ICC 605-202X edition

First Committee Action Report on the initial draft edition of the ICC 605 Standard

**For Committee Actions taken on the
Public Input Agenda based on the
November 12, 2024, public input initial
draft at the meetings held on Microsoft
Teams March 10, 24, April 14, May 12,
June 2, 30, and July 21, 2025.**

Figure 301.2: Provided defensible space for each side of dwelling building.

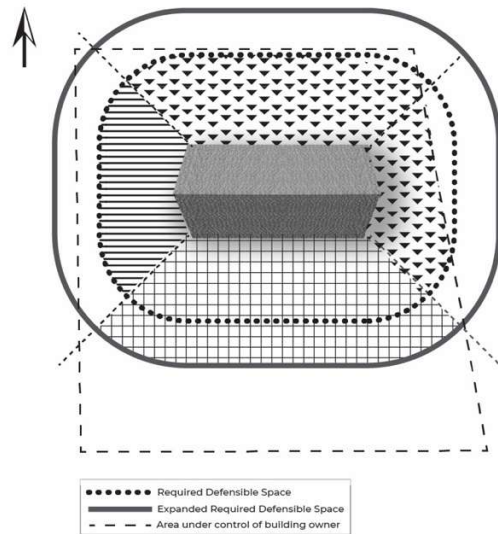
3. In Figure 301.2, should each hatched area of plan be defined? Also consider labeling the different perimeter lines in lieu of the legend provided, to improve clarity.

It seems like Figure 301.2 should also be referenced in the first paragraph of Section 301.2 to parallel the second paragraph. Each paragraph is its own self-contained provision, first for new construction, then for existing structures being repaired, altered or added to.

What is described in the text doesn't match the figures showing a sides exposure in Figure 301.2. The figure shows a sides exposure extends out at a 45-degree angle from the buildings corner, but the text refers to the exposure only along the entire length. Adding "side of the" in the text refers to the whole exposure area more clearly.

301.2. Buildings Dwellings. New dwelling ~~buildings~~ constructed in, or ~~buildings~~ relocated into *wildfire hazard areas* shall be evaluated based on the provided *defensible space* distance and expected exposure. Each side of the structure shall be assessed independently ~~for each side of the structure~~ in accordance with Table 301.2 and Figure 301.2 and comply with the requirements of this standard.

Repair, addition, or alteration of *existing* dwelling ~~buildings~~ in *wildfire hazard areas* shall comply with Chapter 6, based on provided *defensible space* distance and assessed independently for each side of the structure in accordance with Table 301.2. Provided *defensible space* area for each side of the structure shall be in accordance with Figure 301.2.

❖ Note: Further information provided in the commentary of this chapter. Different hatched areas show provided defensible space on each side of the dwelling.

Figure 1. Required defensible space around building

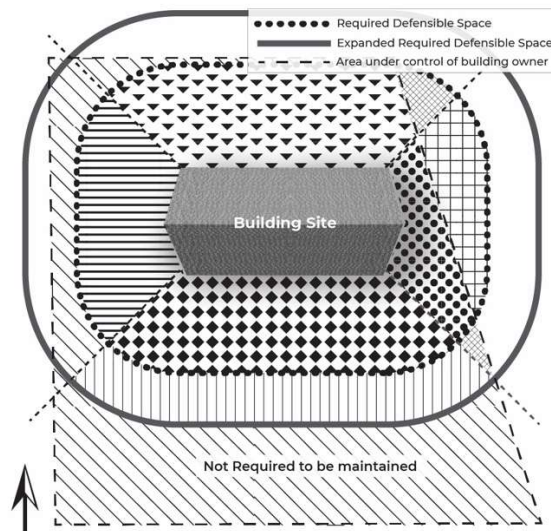
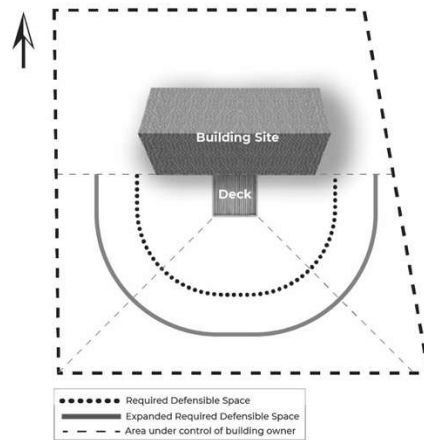
The caption for Figure 301.2.1 is revised to remove the word required. This figure does not show the “required” defensible space. The figure shows the required defensible space and 1.5 x defensible space. So which is required? They cannot both be required, because they are not the same.

~~❖301.2.1. Example for designing an unclosed accessory structure in wildfire hazard area~~
Replace this drawing with new drawing with two exposed sides

❖ 301.2. Example for designing a dwelling building in ~~WHA~~ *wildfire hazard area*. Figure 1 provides an example for designing dwelling buildings and structures based on the provided defensible space on each side. ~~In this~~ This example dwelling building is located in an area with extreme wildfire hazard and according to table 402.3, the required defensible space distance in this condition is equal to 100 ft. As it is shown in Figure 1:

- On northern side of the dwelling building, the area under control of the dwelling building owner is less than required defensible space (~~blue arrow shows the area outside control of building owner~~ Diagonal crosshatched area). As a result, this side must be constructed by considering direct flame contact, radiation heat and ember exposures and in accordance with ~~WHA~~ Wildfire Hazard Area Construction Class 1 (Section 503). The fuel modification area on this side (~~purple area~~ triangle hatched area) will be limited to the ~~lot lines or~~ required defensible space distance line (~~green dot line~~) ~~whichever is less~~.

- On the eastern side of the dwelling building, the area under control of the dwelling building owner is less than required defensible space (Crosshatched area). As a result, this side must be constructed by considering direct flame contact, radiation heat and ember exposures and in accordance with Wildfire Hazard Area Construction Class 1 (Section 503). The fuel modification area on this side (dot hatched area) will be limited to the lot lines or required defensible space distance whichever is less.

- b. To resist against ember and radiation heat exposures and in accordance with Wildfire Hazard Area Construction Class 2 (Section 504). In this case, the fuel modification area on this side (diamond hatched area) will be limited to the required defensible space line.

- c. To resist against ember, radiation heat and direct flame contact exposures and in accordance with Wildfire Hazard Area Construction Class 1 (Section 503). In this case, the fuel modification area on this side will be initiated from edge of the southern exterior wall of dwelling building and extends 5 ft horizontally away from the perimeter of all projections.

~~Figure 2. Required defensible space around unenclosed attached accessory structures.~~

FIGURE 402.3
~~PROVIDED~~ DEFENSIBLE SPACE AREA AND FUEL MODIFICATION ZONES

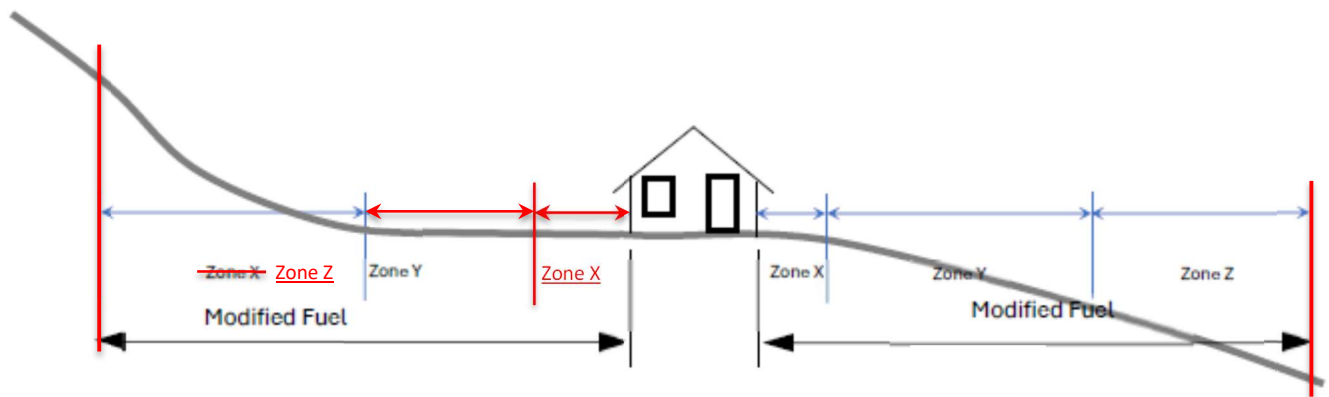
- The word “provided” is deleted in Section 402.3. Each of the three zones may or may not be provided on any specific site. The referenced figure shows where the various zones are located. The same revision is made to the title of Figure 402.3.
- In Section 402.3, the 2nd sentence is delete. This sentence makes is confusing and based on Figure 402.3 it does not apply. The sentence states “...where two or more different zones overlap...” Where and how will different zones overlap? It is clear in Figure 402.3 that Zone Y starts at the outer boundary of Zone X, so there is no overlap. The same applies for the boundary between Zone Y and Zone Z.

- In Figure 402.3, Zone X is shown as the furthest zone from the building on the uphill side. That zone should be labeled as Zone Z.
- In Figure 402.3, Zone X starts at the building and is not shown on the uphill side. Zone X is added on the uphill side of the building.

- In Figure 402.3, Additionally, revisions are made in the graphic to extend the vertical line at the far left of the figure to show that it reaches the ground level. This indicates that the zone, even though measured horizontally, still must be maintained at the ground surface. Likewise, a vertical line is added at the far right to indicate this is the area of modified fuel and to extend the line to the ground surface.

- The title for Figure 402.3 is revised to delete the word “provided”. Zone Z may or may not be provided in any specific situation. This figure shows where the zone boundaries are located and how to measure the distance of fuel modification. The word provided is not appropriate for this figure.

4. In Section 402.2.4, do the landscaping requirements not apply when a Landscape Plan is not required by the Enforcing Agency?
5. In Figure 402.3, Zone X and Zone Y are reversed in the uphill (left) portion of the figure.

402.3 Defensible space zones. The provided defensible space is the area as zones are the areas shown in Figure 402.3. Each zone represents the area where the vegetation is modified and maintained to create a defensible space between the structure and the surrounding area. ~~In areas where two or more different zones overlap, the most stringent zone requirements shall apply.~~

FIGURE 402.3
~~PROVIDED~~ DEFENSIBLE SPACE AREA AND FUEL MODIFICATION
ZONES

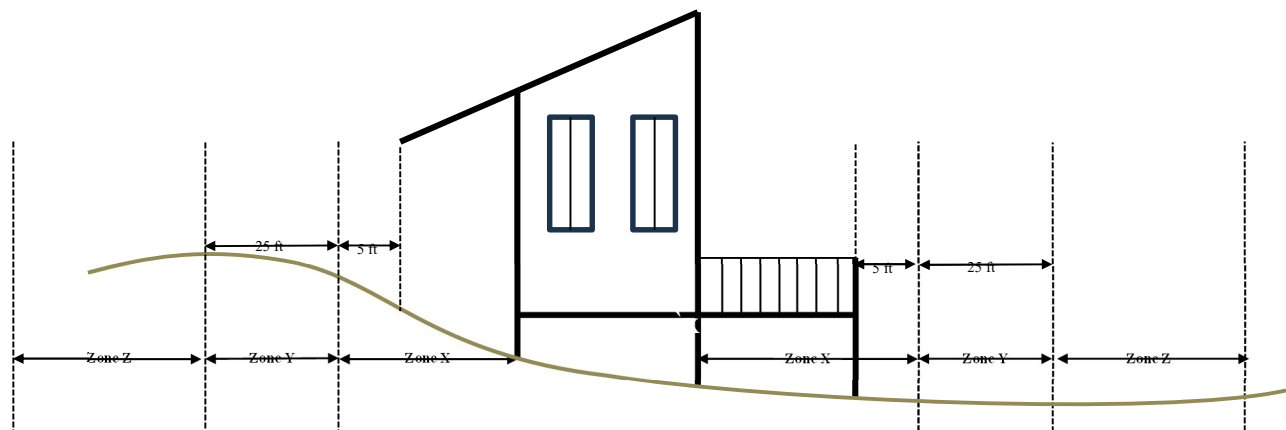
[Note: remove the overhang from here and make another drawing for Zone X.]

402.3 Defensible space zones. The provided defensible space is the area as zones extend horizontally from the building as shown in Figure 402.3 and include Zone X, Zone Y and Zone Z as applicable in accordance with Sections 402.3.1, 402.3.2 and 403.3.3. that Each zone represents the area where the vegetation is modified and maintained to create a defensible space between the structure and the surrounding area. In areas where two or more different zones overlap, the most stringent zone requirements shall apply.

FIGURE 402.3
PROVIDED DEFENSIBLE SPACE AREA AND
FUEL MODIFICATION ZONES

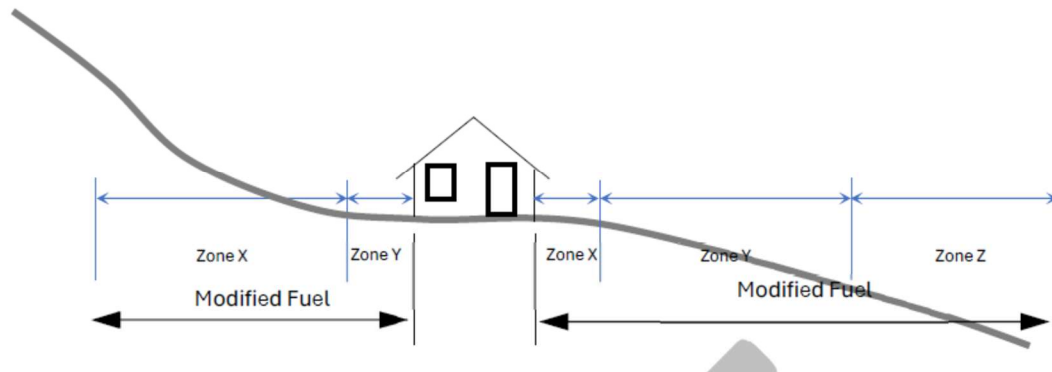
Changes in the figure above:

This comment provides a correction to Figure 402.3.

1. **Defensible space zones.** The provided defensible space shall extend horizontally from the building is the area as shown in Figure 402.3 and include Zone X, Zone Y and Zone Z as applicable in accordance with Sections 402.3.1, 402.3.2 and 403.3 that represents the defensible space between the structure and the surrounding area. In areas where two or more different zones overlap, the most stringent zone requirements shall apply.

❖ COMMENTARY FIGURE 402.4.3 – Required Defensible Space Determination Method

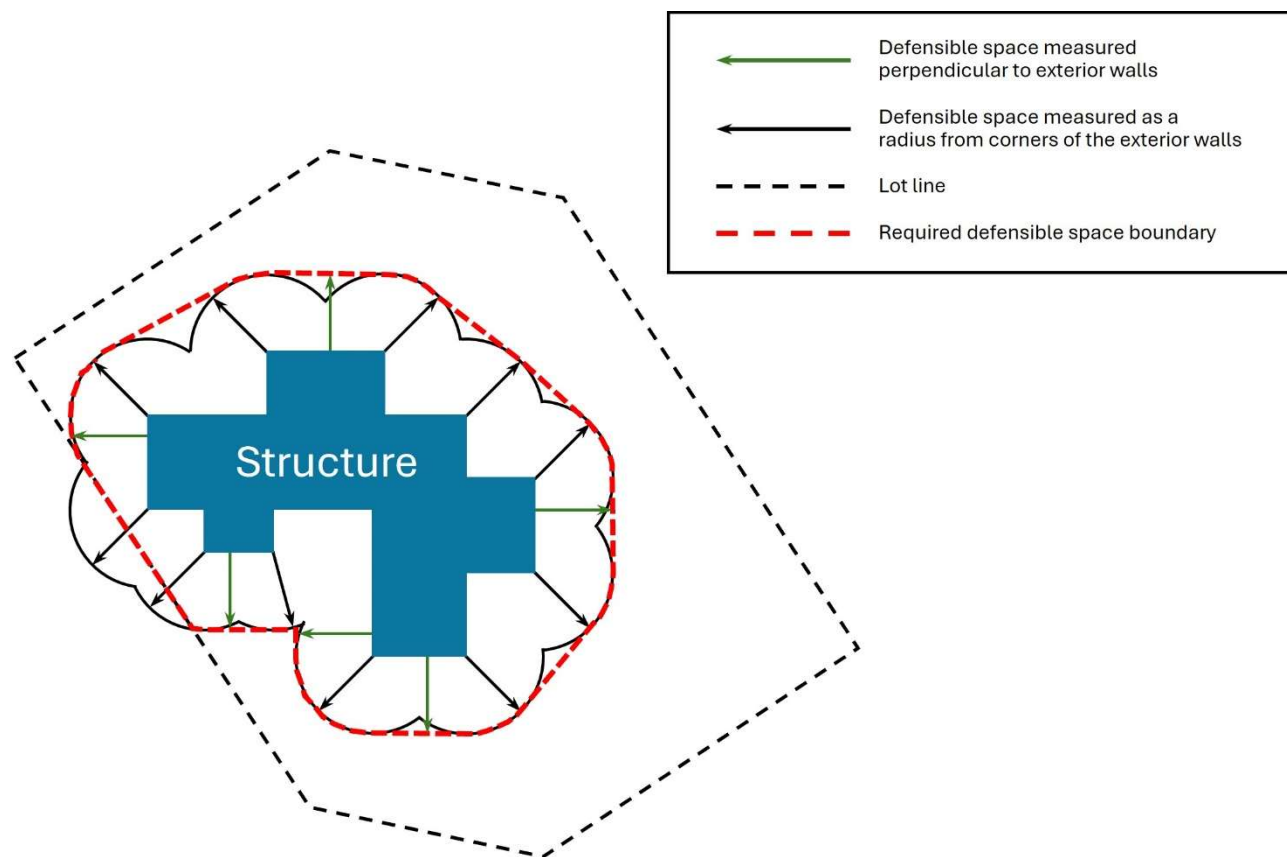
Commentary Figure 402.4.3 confusing. The end goal for the code user is to show the actual perimeter of the required defensible space, but that is not shown. This proposal revises the graphic to resolve this issue.

Figure 1. Required defensible space around building

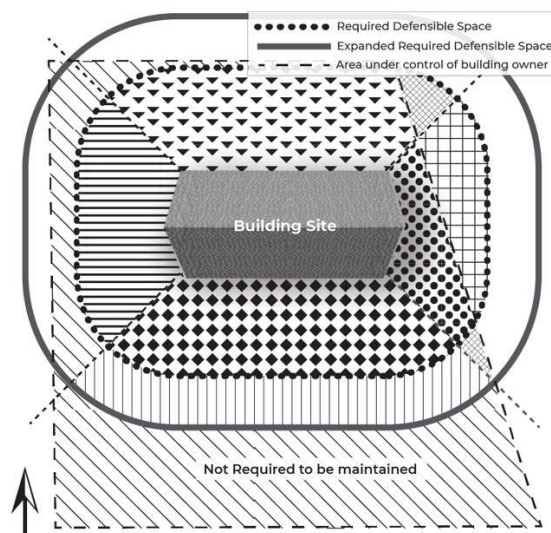
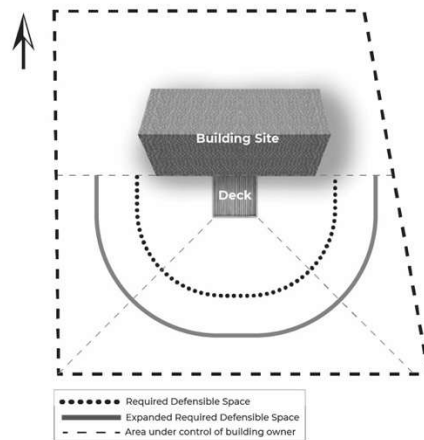
1. The commentary for Section 301.2 is revised to remove the acronym WHA. Additional grammatical corrections are included in this commentary.
2. The caption for Figure 301.2.1 is revised to remove the word required. This figure does not show the “required” defensible space. The figure shows the required defensible space

~~❖301.2.1. Example for designing an unclosed accessory structure in wildfire hazard area~~
~~Replace this drawing with new drawing with two exposed sides~~

❖ 301.2. Example for designing a dwelling building in ~~WHA~~ wildfire hazard area. Figure 1 provides an example for designing dwelling buildings and structures based on the provided defensible space on each side. ~~In this~~ This example dwelling building is located in an area with extreme wildfire hazard and according to table 402.3, the required defensible space distance in this condition is equal to 100 ft. As it is shown in Figure 1:

~~Figure 2. Required defensible space around unenclosed attached accessory structures.~~
